License to Operate On-Site Sewage Treatment and Disposal Facility

Issued This Date: 02/18/2020 Permit Number: 108932

Location Description: 185 MITCHELL DR
SPRING BRANCH, TX 78070

COMAL COUNTY OFFICE OF ENVIRONMENTAL HEALTH ***
APPLICATION FOR PERMIT FOR AUTHORIZATION TO CONSTRUCT AN
ON-SITE SEWAGE FACILITY AND LICENSE TO OPERATE

Site Map
Aerobic with Drip Irrigation
Disposal System
Texas 46 RV Park, LLC
Brandon Acres, Unit 1, Lot 1-A
185 Mitchell Drive
Spring Branch, Texas 78070
Comal County
Scale 1" = 85'
100 yr flood plain does not exist on this tract

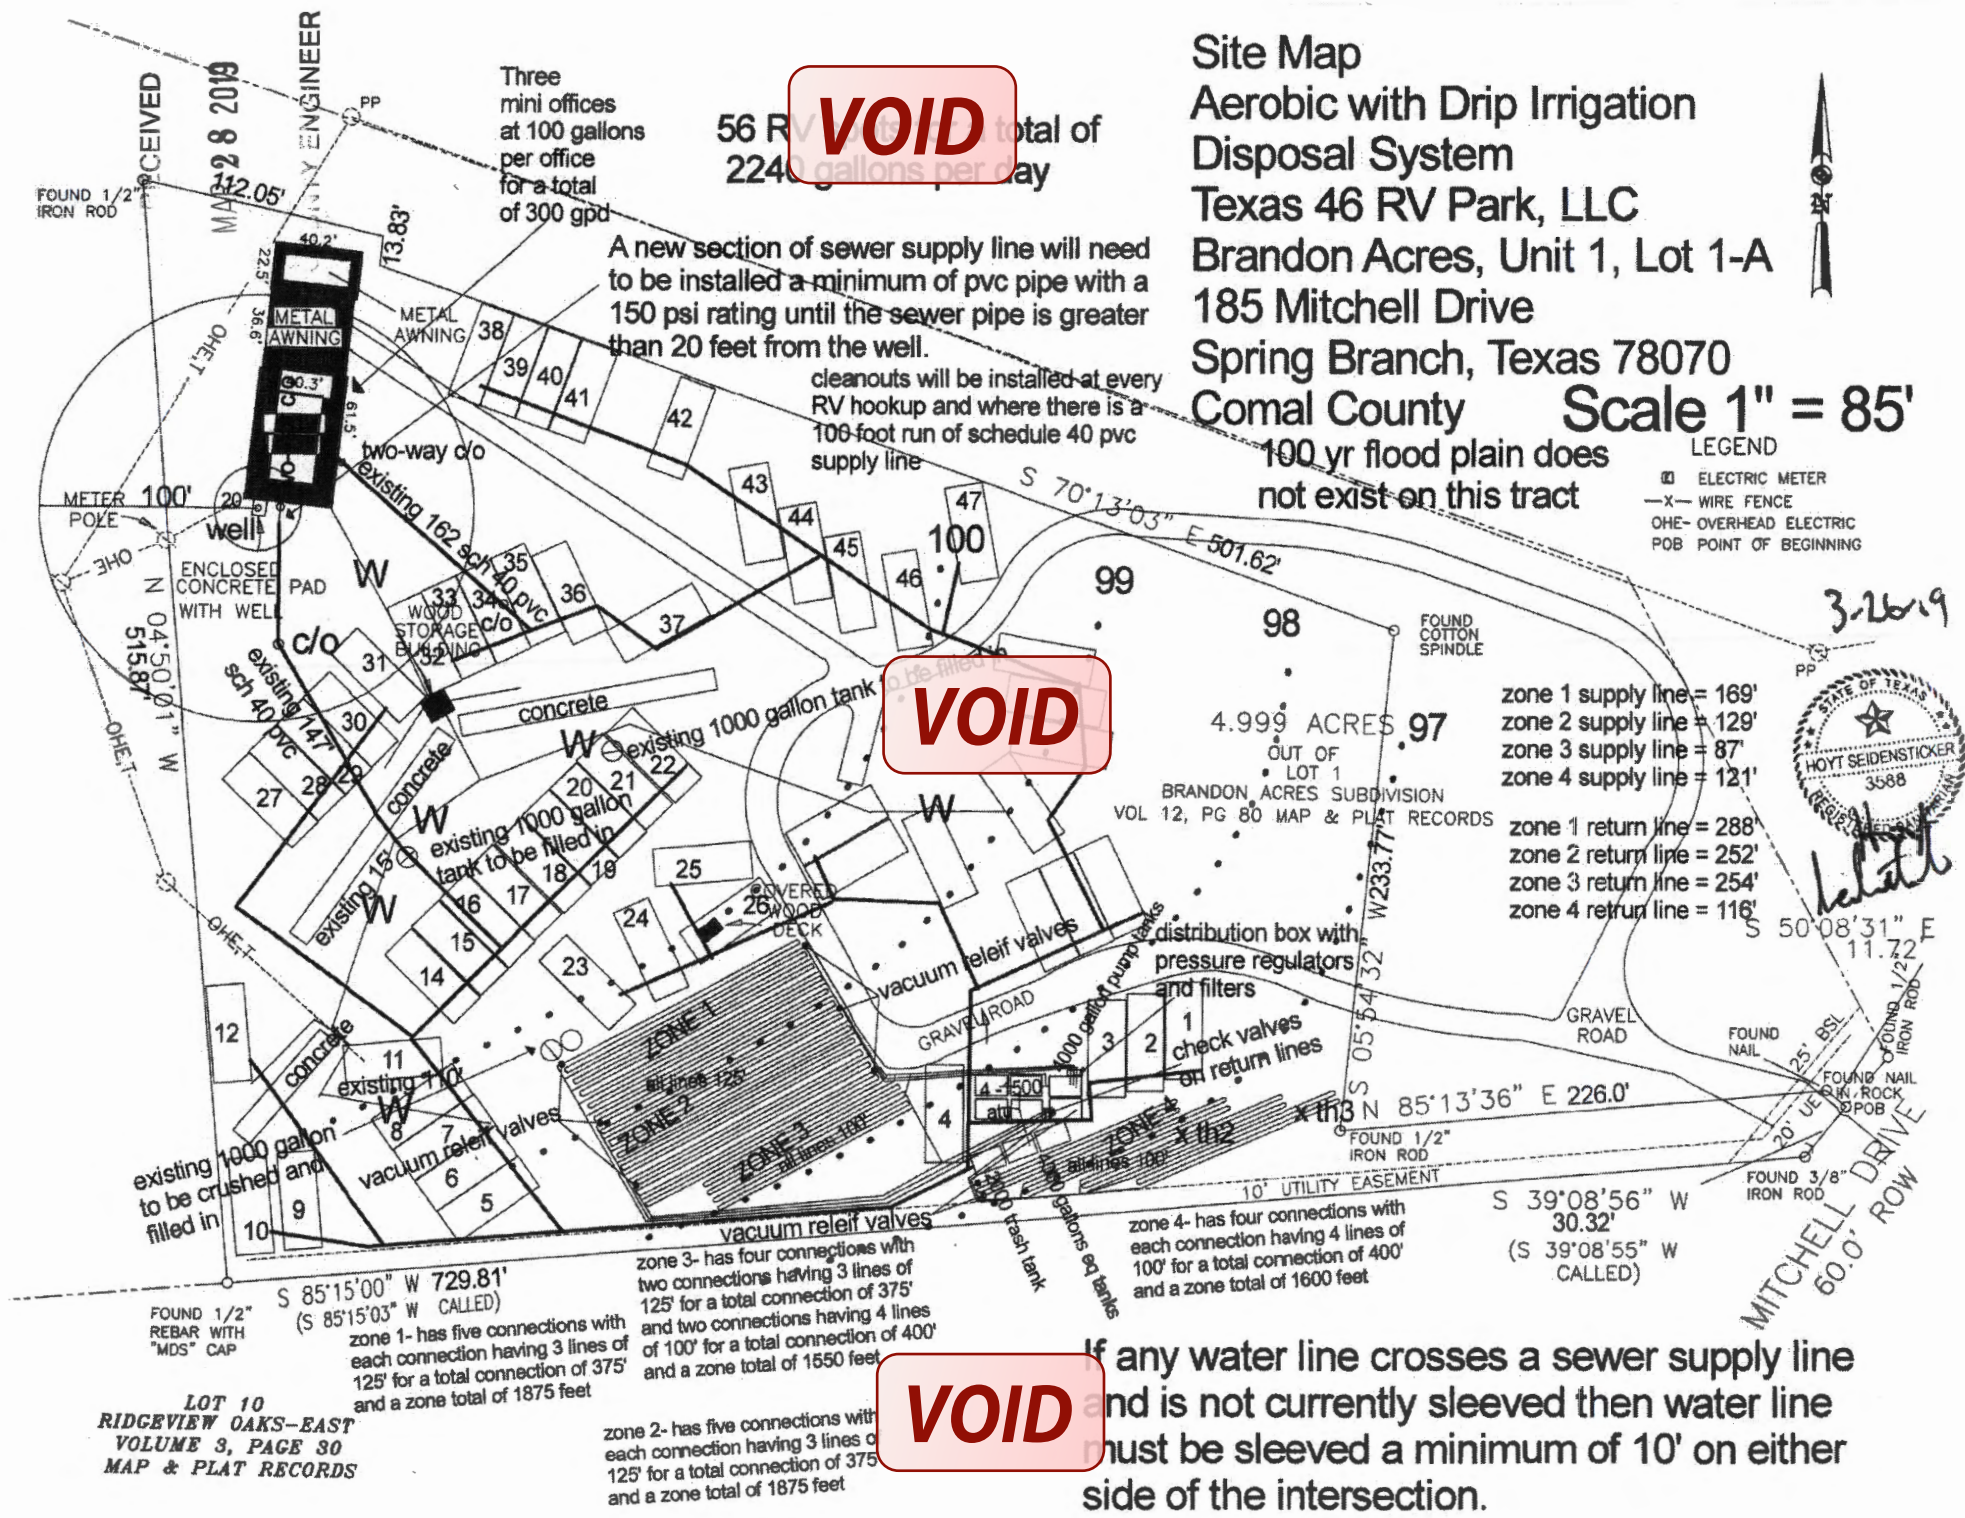
- 6 ✓ Indicate the total absorption area on the permit application.
- 7 ✓ Identify all the RV locations, and show the waterline location to each RV pad.

- 8 ✓ Show the 150 foot water well radius.
- 9 ✓ Comal County rules and regulations require that new non-single family residential structures show adequate land area for doubling the required land needed for the treatment units and disposal area.

- 10 ✓ Show the cleanout location at every 100 feet of tightline.
- 11 ✓ Indicate if equivalent protection is needed for the sewer supply lines that appear to be located under the driveway.

12. Revise accordingly and resubmit.
